Product Change Notification

Date Issued :	October 10, 2022	PCN Number :	512712
Reason for Change :	Capacity change or tool replacement		
Description of Change :	This notice is to inform you that Molex Lincoln Nebraska is adding replacement tooling that will affect the product listed. New tooling will be exact replica of current tooling. There will be no change to the product Fit, Form, Function or Appearance when compared to current tooling. Current tooling will be taken out of service once new tooling is qualified.		
Assessment of Change :	First Article Inspection		
Planned Implementation Date :	April 10, 2023		
Sample Availability Date:	February 16, 2023		
Internal Molex Qualification Date :	March 13, 2023		
Last date to request Samples by Customer :	February 27, 2023		
Traceability Code Markings / Date :	Product made after planned implementation date can contain the change

■ 5566
— Mini-Fit

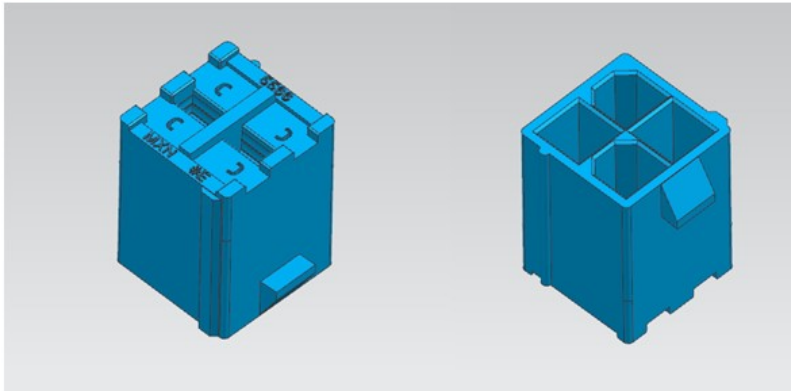
- To ensure exceptional quality, Molex Lincoln Nebraska is going to replace tooling which produces the affected part numbers
 - New tooling will be an exact replica of current tooling
 - Tooling being added to keep up with current and future demand
- There is NO impact to Fit, Form or Function
- Samples available upon request after date shown above
- Part Numbers Impacted
 - See attached list
